**Market Street  
Marine Terminal  
Functional Replacement Project  
Portsmouth, NH**

# **NHDES Wetlands Permit Application Amendment & Request for More Information Response**

**NHDOT Project 15731  
Federal Project A000(909)  
NHDES File No. 2022-00429**

**RE: NHDES Request for More Information Response  
Standard Dredge and Fill Wetlands Permit Application (RSA 482-A)  
NHDES File Number: 2022-00429  
Subject Property: Market Street Marine Terminal, Portsmouth, Tax Map #119, Lot #5**

Figure 1: July 7, 2013, Eelgrass Survey Study Area 1

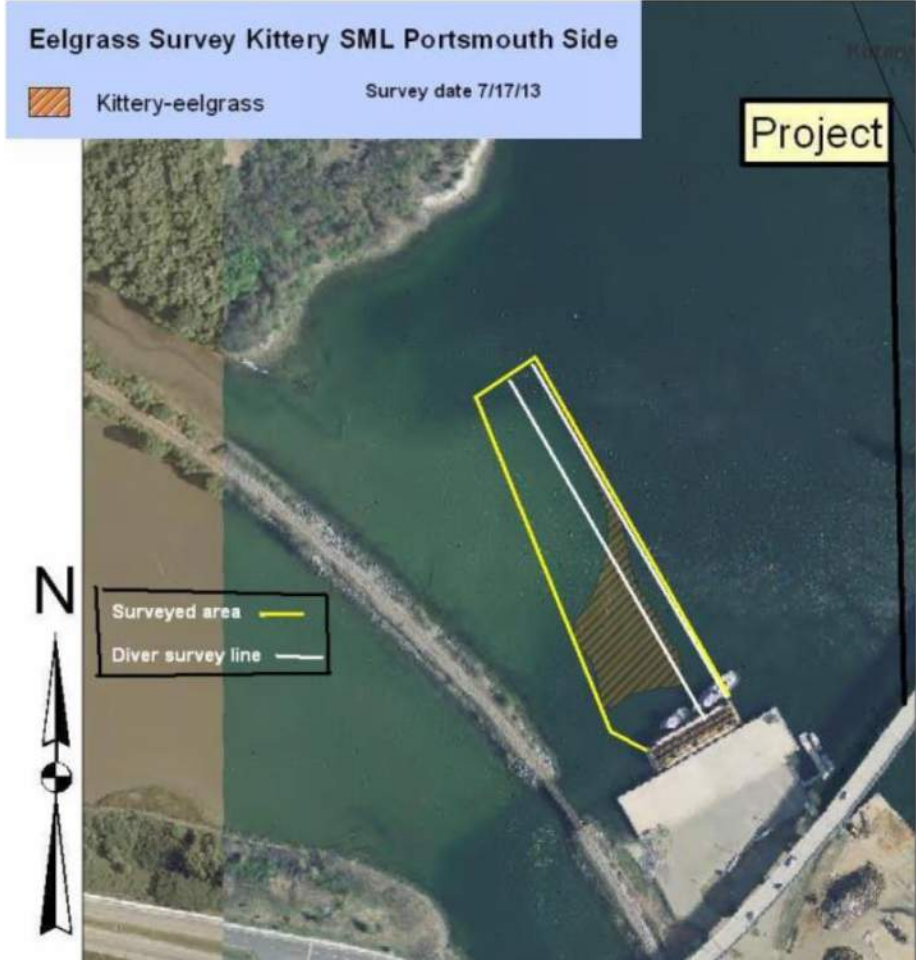
11. The application indicates that there is past evidence of eelgrass beds within the vicinity of the project. In order to meet the design requirements in Env-Wt 606.03(f), Env-Wt 606.06(c) and meet the requirements in Env-Wt 302.04(a)(7), please perform a survey for eelgrass beds in the vicinity of the project and submit any supplementary maps and other applicable documentation identifying the project location and extent of all proposed impacts in relation to all historic and existing eelgrass beds and if any are located within the vicinity of the project, please revise the plans to identify the location of those resources.

*At the request of NOAA, eelgrass surveys were conducted in July and August 2013, by MaineDOT dive crews for the Sarah Mildred Long Bridge Replacement Project. The study areas included in the survey included areas in the vicinity of previously documented eelgrass beds, including the area north of the existing bridge in the vicinity of the proposed floating dock, as well as the northern end of the wharf extending out beyond Pier 15. The results of the survey indicated sporadic eelgrass shoots, but not a dense enough population of plants to form a bed. The study areas from the 2013 surveys are depicted on Figures 1 and 2 below.*

**G-101**  
 SHEET 6 OF 18

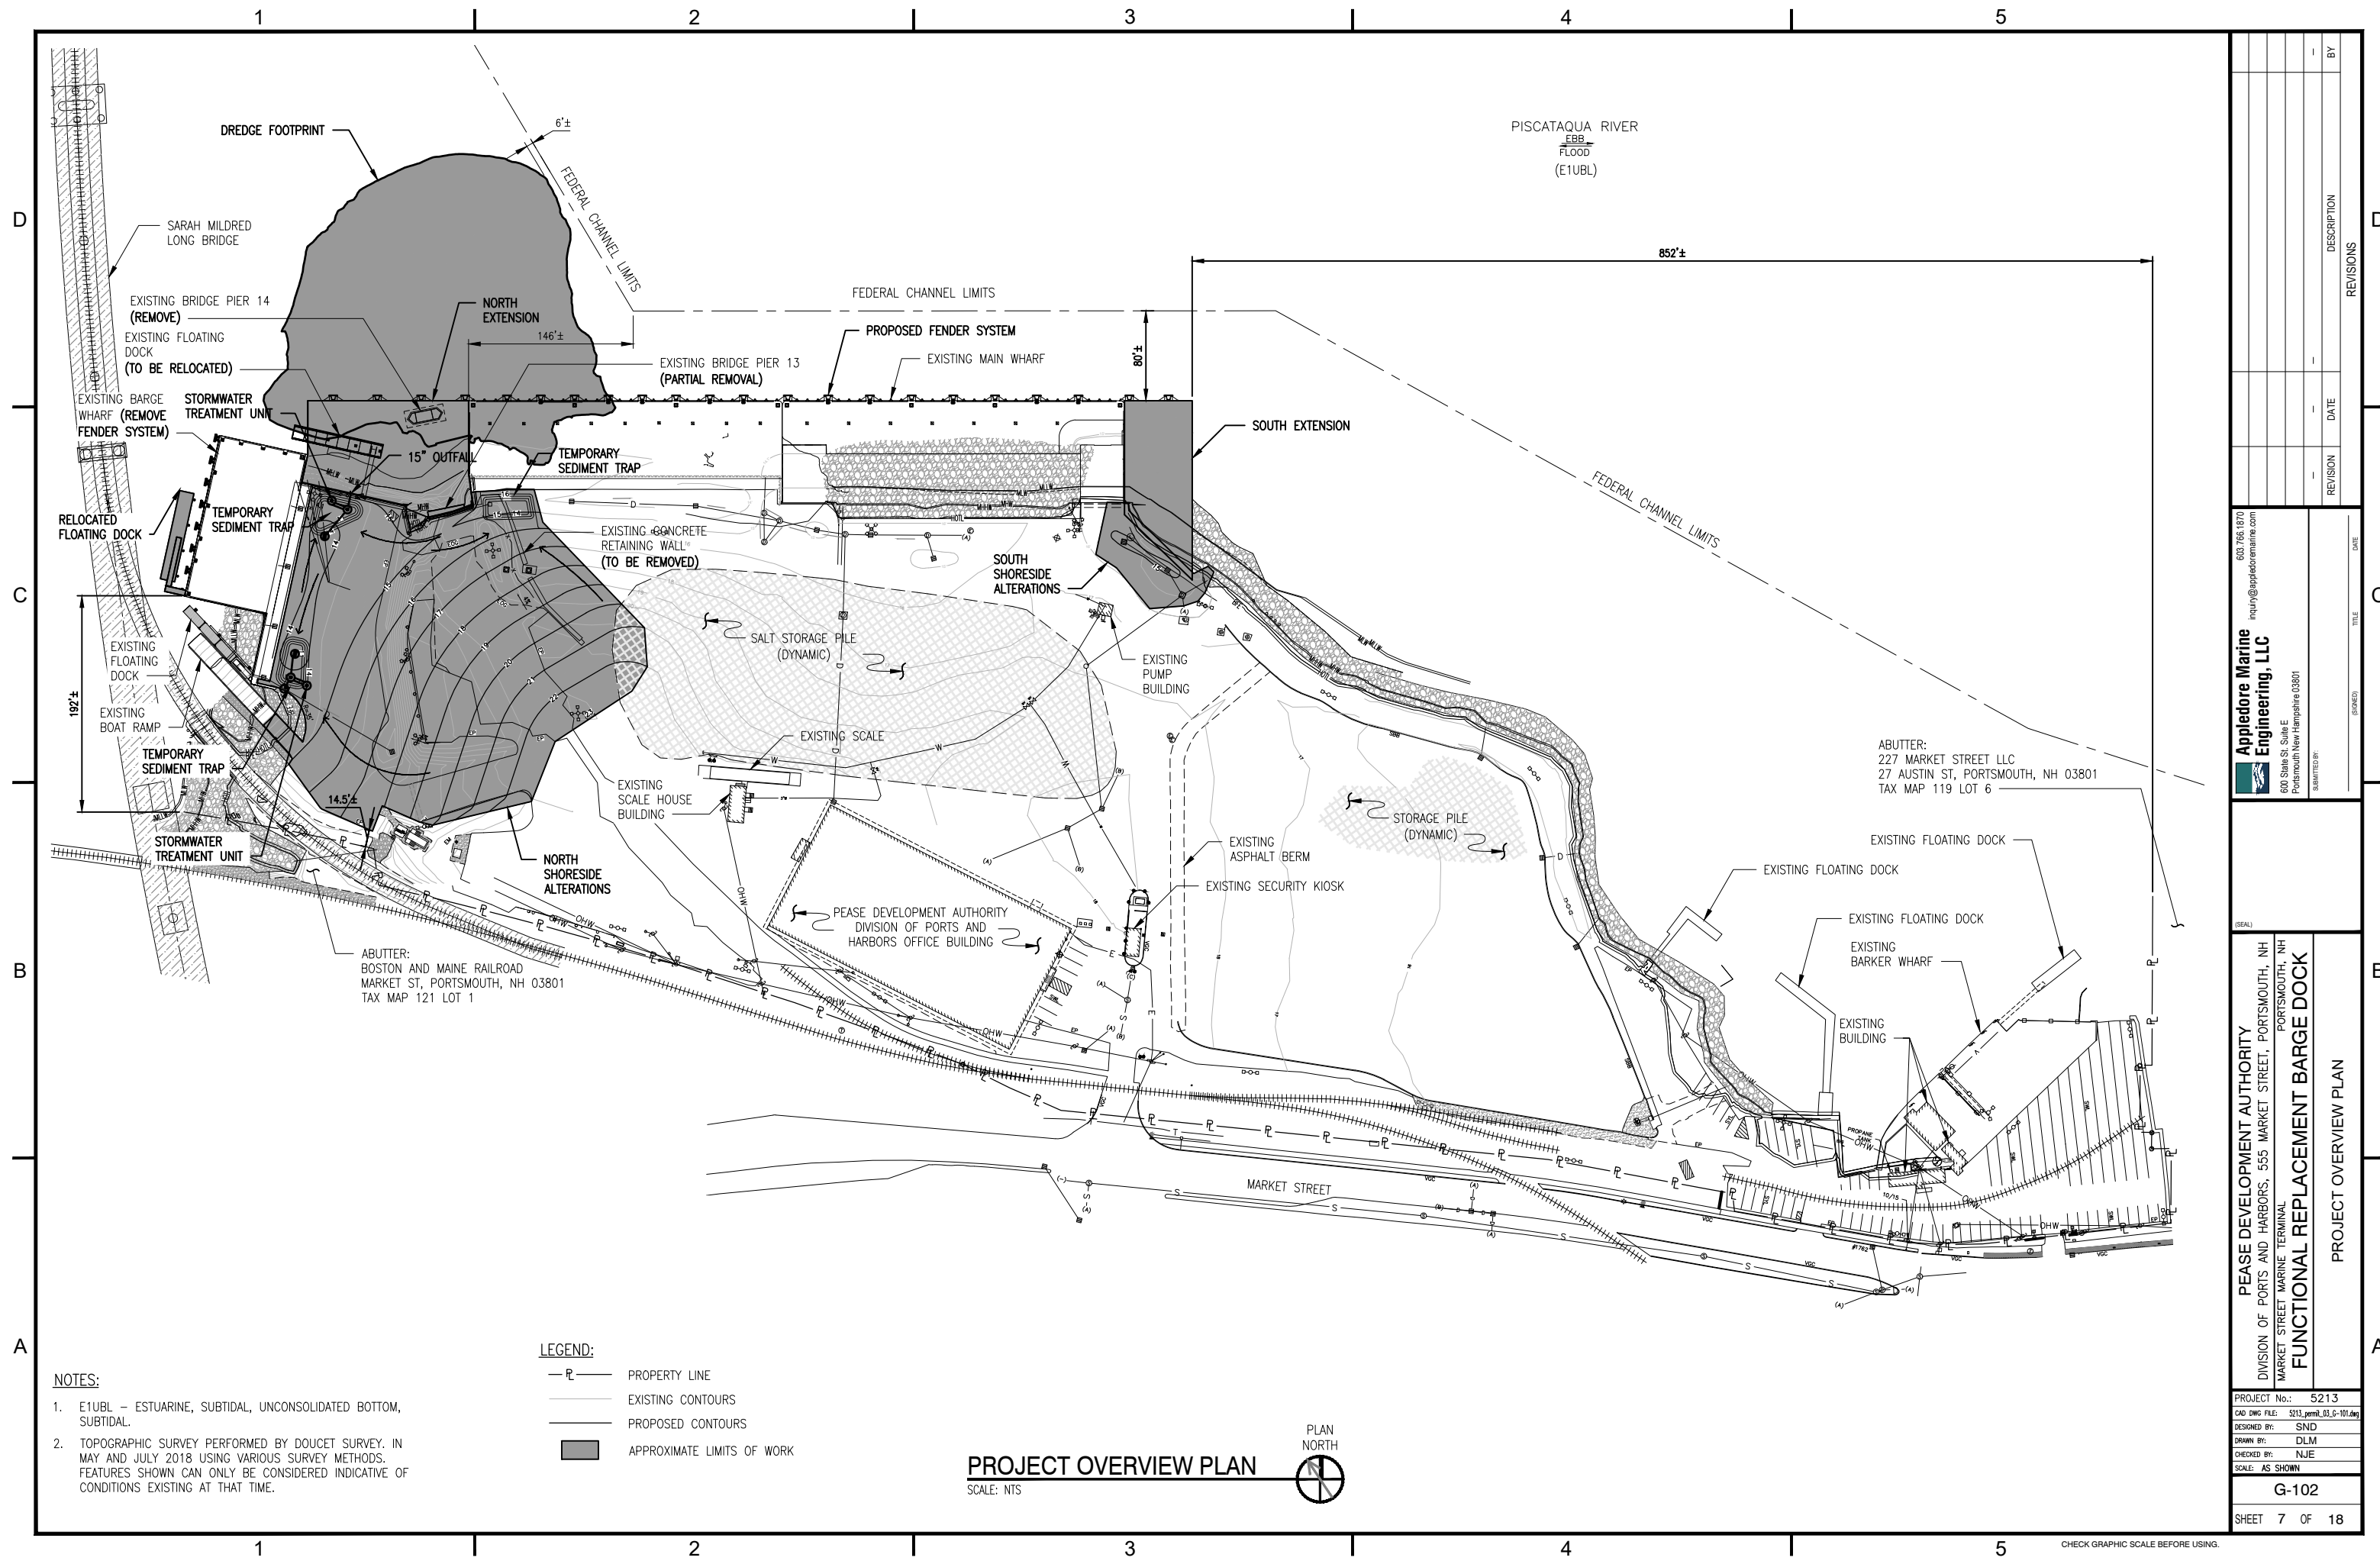
- 
- c. A plan note identifying the means and methods used to perform the delineation, the date on which the wetland delineation took place, and the name of the wetland scientist responsible for the wetland delineation in accordance with Env-Wt 501.02(a)(2)k. and Env-Wt 501.02(b)(3).

3. As this project affects the surface water shoreline of the Piscataqua River, please revise the plans to include the following in accordance with Env-Wt 501.02(c):

*Please refer to the attached revised Impact Plans for the updated existing conditions plan (Sheet 6 of 18). Wetlands and surface waters were delineated by Christine Perron (CWS No. 294), of McFarland-Johnson, Inc. on April 2, 2019, in accordance with the Corps of Engineers Wetland Delineation Manual and the Regional Supplement to the Corps of Engineers Wetland Delineation Manual: Northcentral and Northeast Region, Version 2.0, January 2012, US Army Corps of Engineers.*

*Please refer to the attached revised Impact Plans for the updated existing conditions plan (Sheet 6 of 18), including the stamp of Christine Perron (CWS No. 294) of McFarland-Johnson, Inc.*

*Please refer to the attached revised Impact Plans for the updated existing conditions plan (Sheet 6 of 18) that includes the shoreline and HOTL along the full project parcel (tax map 119, lot 5).*

*Please refer to the attached revised Impact Plans for the updated existing conditions plan (Sheet 6 of 18) and project overview plan sheet (Sheet 7 of 18) depicting the footprints of existing and proposed structures on the property (tax map 119, lot5).*

**PROJECT OVERVIEW PLAN**  
SCALE: NTS

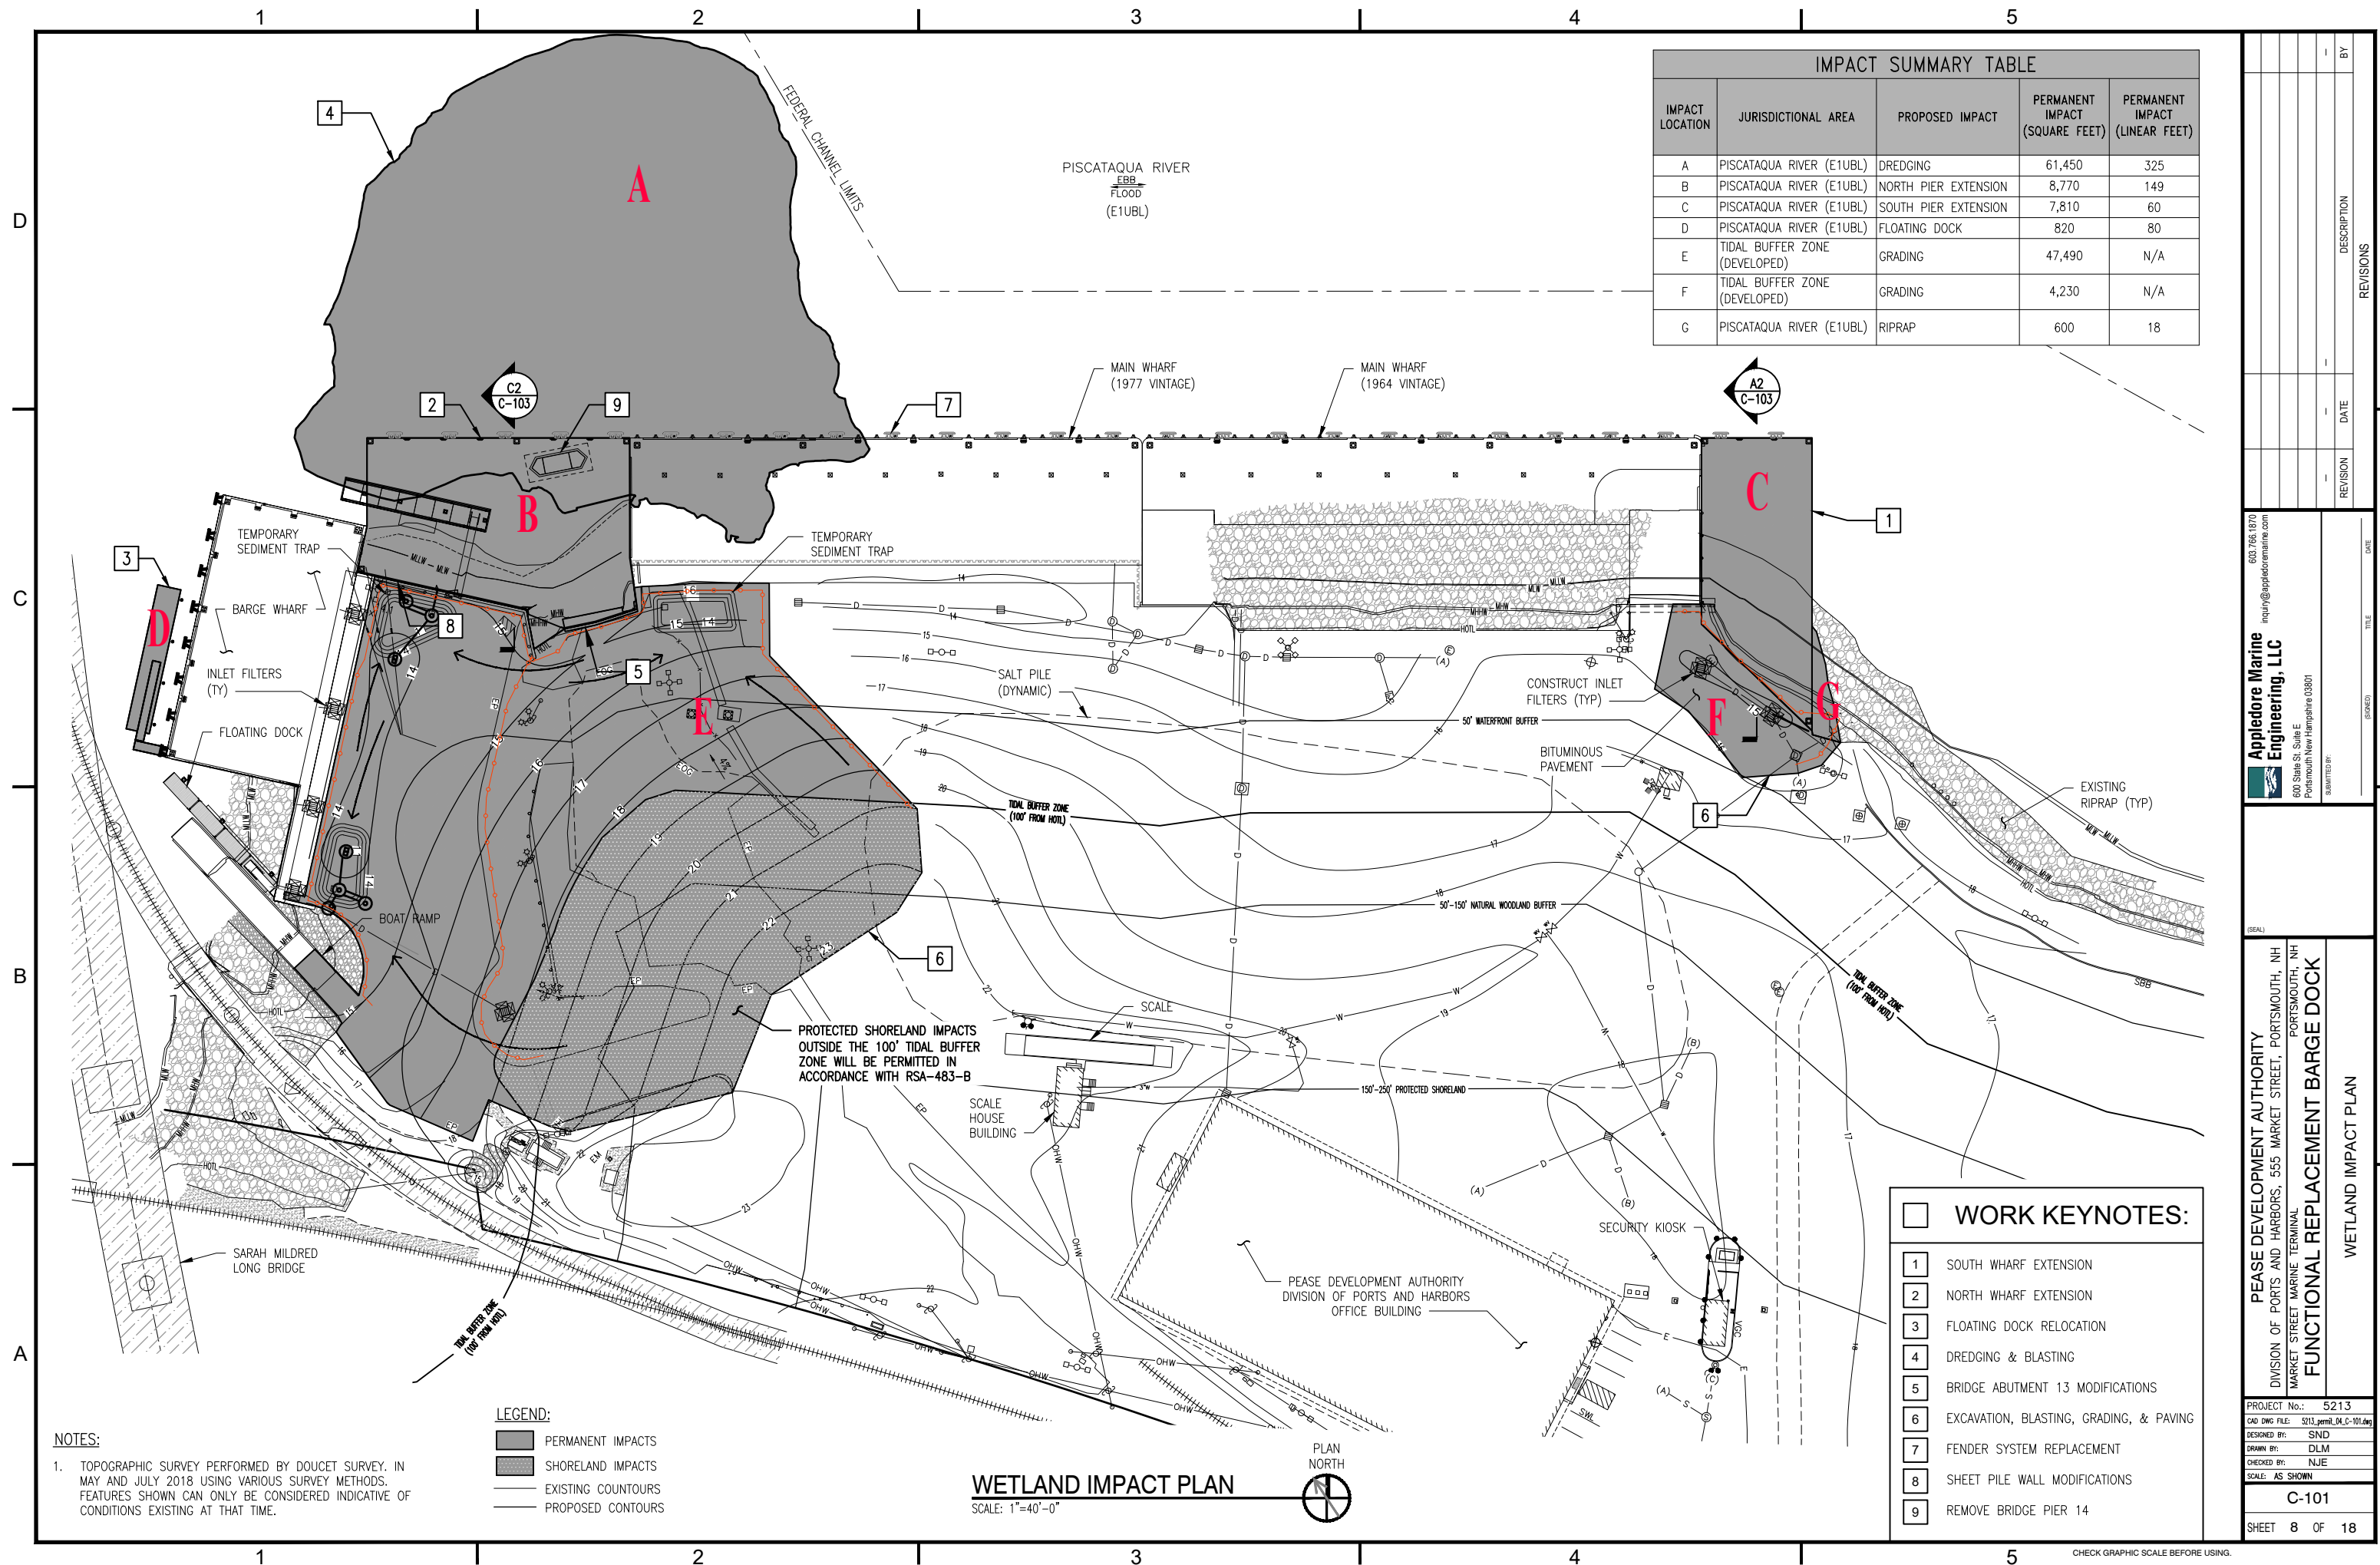
- 
4. Please revise the plans to include the following in accordance with Env-Wt 501.02(a):
- a. An overview of the full property and proposed impact areas in relation to the property lines in accordance with Env-Wt 501.02(a)(2)(e).

*Please refer to the attached revised Impact Plans for the updated existing conditions plan and project overview plan sheet (Sheets 6 and 7) depicting the full property, proposed impact areas in relation to the property lines, and approximate distances to abutting properties.*

*Please refer to the attached revised Impact Plans for the updated existing conditions plan and project overview plan sheet (Sheets 6 and 7) that includes the existing topography and proposed grading.*

*The proposed 15" stormwater outfall is depicted on the revised plan set (Sheet 7 of 18) included with this response. No current or historic eelgrass beds are located in close proximity to the proposed outfall structure. The outfall is located within an area of existing riprap. The proposed outfall is not anticipated to cause scour or endangered existing vegetation, finfish, crustacea, shellfish or other wildlife.*
